TECHNICAL INSTRUCTION NO. 27.T49B. CAPSTAN MOD. NO. 5.REINFORCING OF THE CANOPY FRONT LAMINATION.

TECHNICAL INSTRUCTION N° 27  
T 49 B. CAPSTAN MOD No 5

REINFORCING OF THE CANOPY  
FRONT LAMINATION

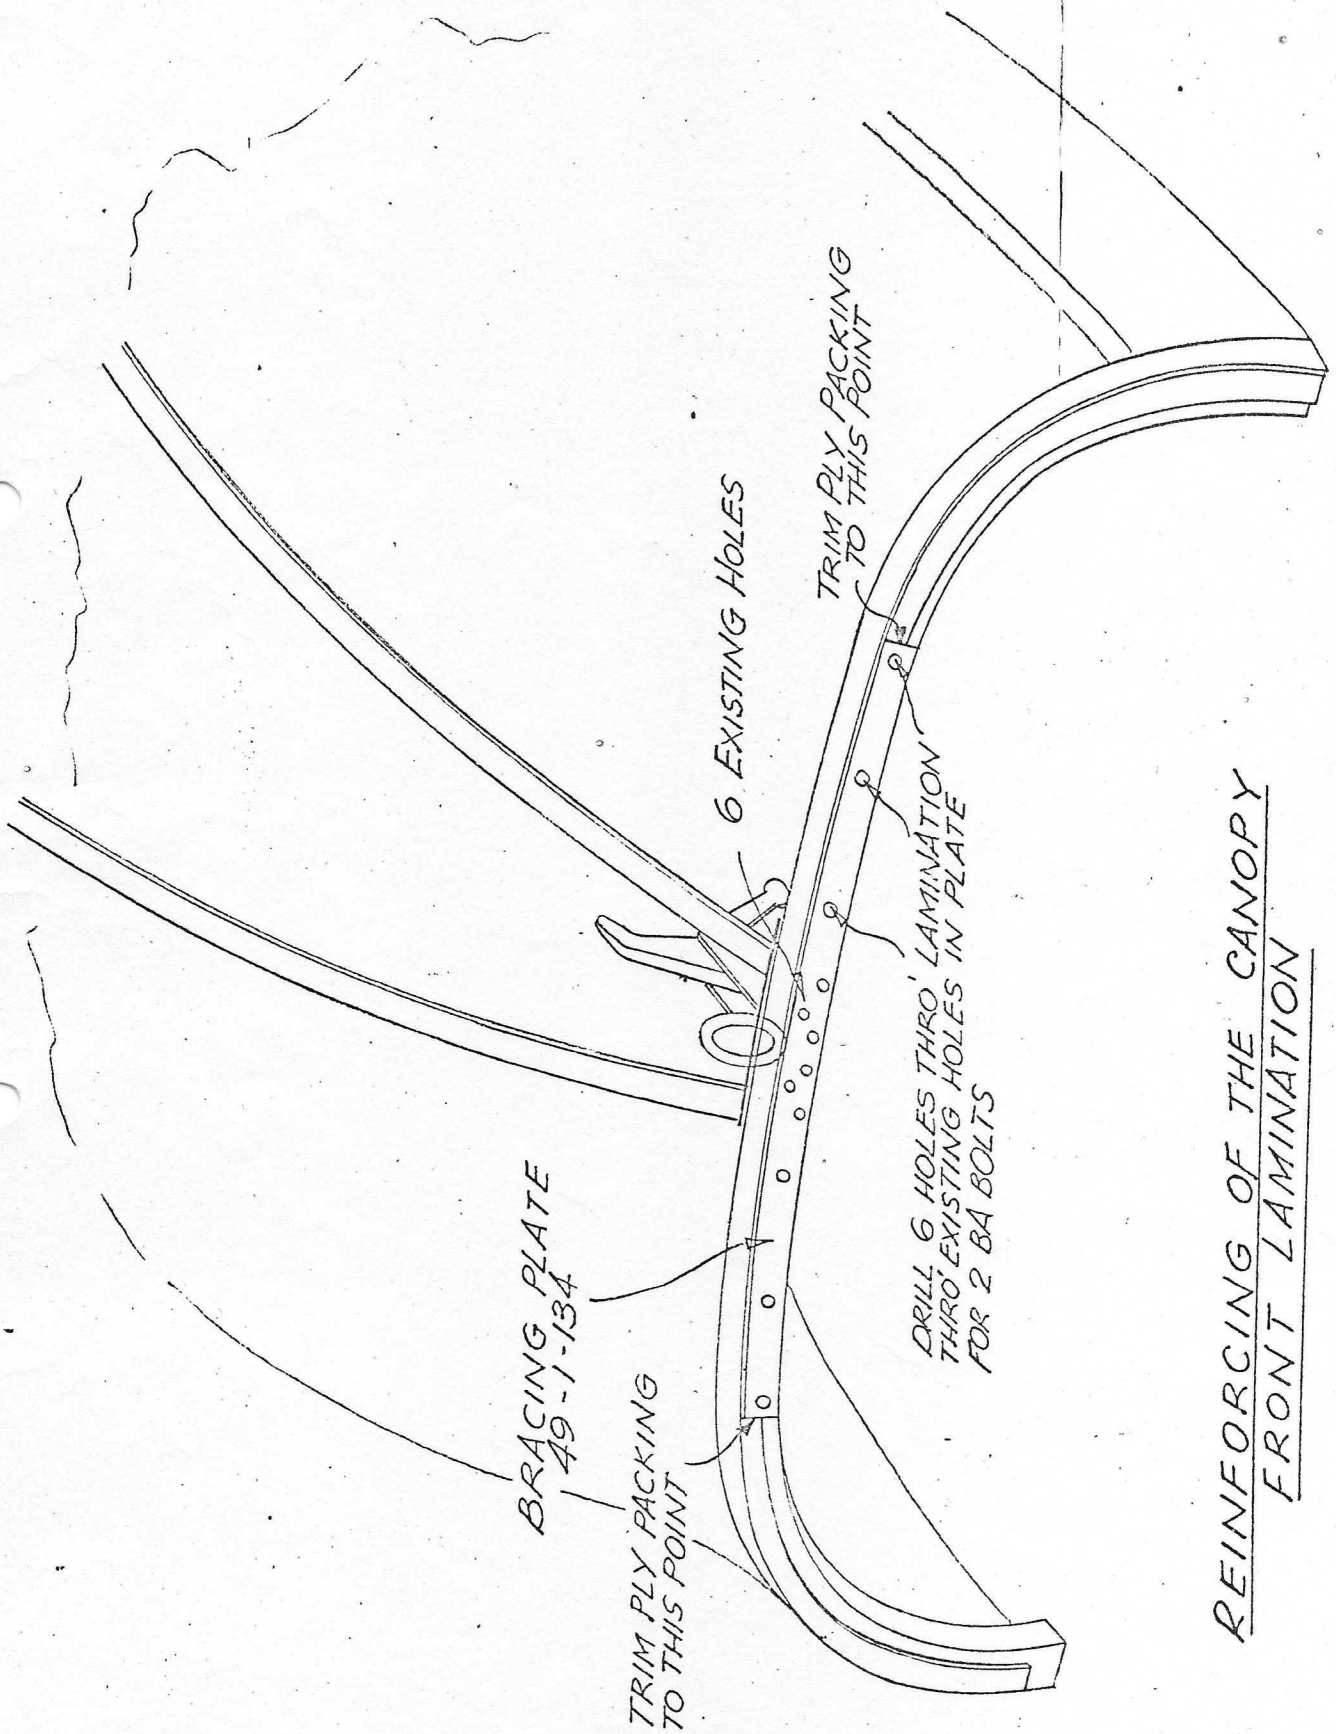
Cases have occurred where the front corner of the canopy has lifted under extreme yawed flight.

The existing plate on the canopy front lamination is replaced by a longer plate.

1. Remove the front plate on the front lamination.
2. Position the new plate by inserting bolts through the centre holes in the plate and the existing bolt holes in the front lamination.
3. Mark the position of the extreme ends of the plate on to the front lamination.
4. Remove the plate.
5. Remove the ply packing on the front of the lamination from the centre to the plate end marks.
6. Fix the new plate by replacing the centre bolts (holding the canopy catch).
7. Drill through the lamination at the hole positions in the new plate.
8. Insert bolts and assemble washers and nuts.
9. Touch up paint as required.

NOTE. Care must be taken, when removing the ply packing from the front lamination, to avoid damage to the perspex canopy.
